The Town of Hilton Head Island Regular Design Review Board Meeting

AGENDA

DESIGN TEAM/ DRB COMMENT SHEET

PROJECT	IHOP- Minor External Change	DRB#	DR110028	
DATE	7/26/2011	RECOMMEND APPROVE <input type="checkbox"/>	RECOMMEND APPROVE W/COND. <input type="checkbox"/>	RECOMMEND DENY <input checked="" type="checkbox"/>

Typical D6.0 Building Remodel

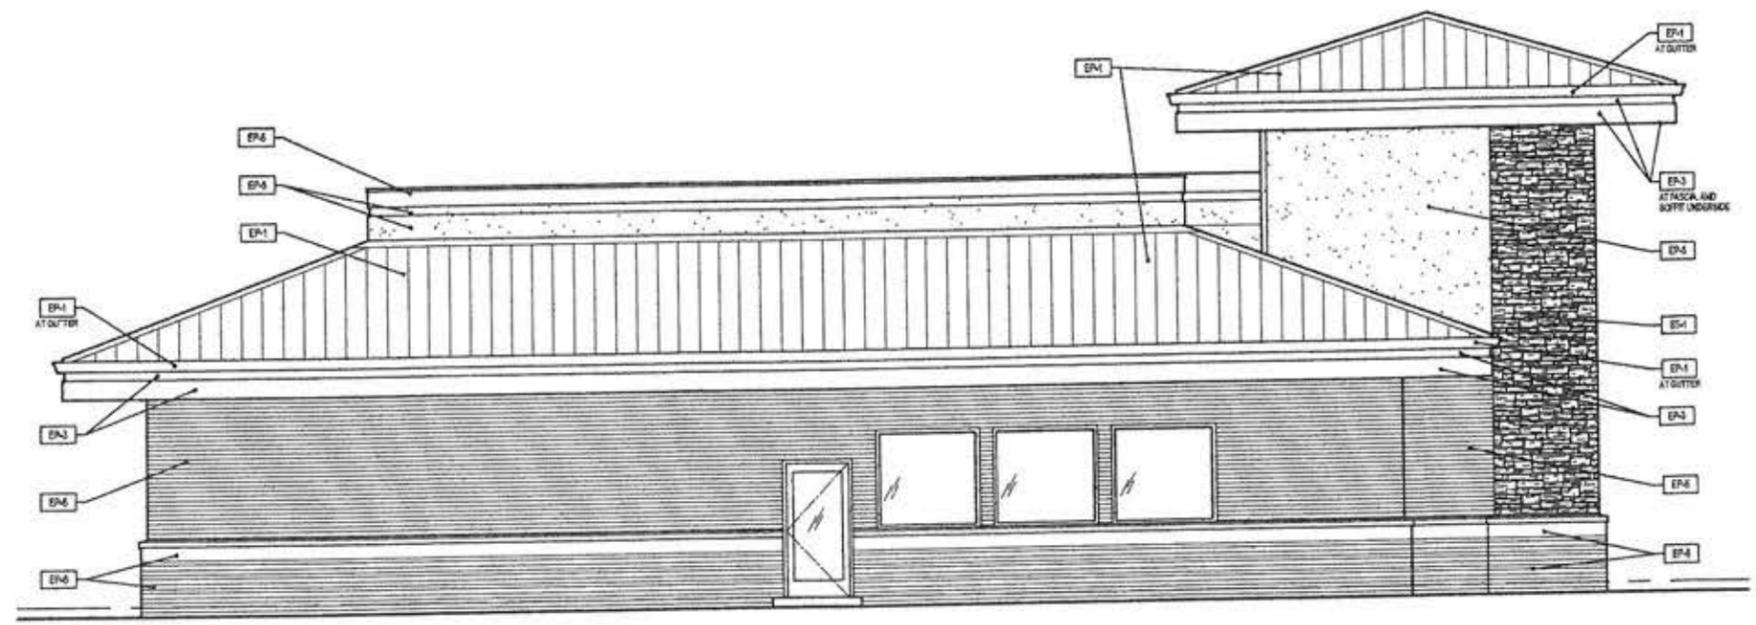
Applicant wishes to reface what are currently stucco columns at the entry with a cultured stone product. Additionally, the applicant would like to place a "copper- finished" panel on the area bounded by the columns and the storefront system.

While the stone would add a quality material to the entry, the stone is foreign to the island's palette and not in keeping with the Design Guide. Continuing upward with the same brick found at the water table might be more appropriate if the applicant still wishes to accent these elements.

Offsetting the panel at the entry would also accentuate it, but the finished proposed doesn't patina, and often ages with an artificial look. Perhaps a warmer material might be more appropriate.
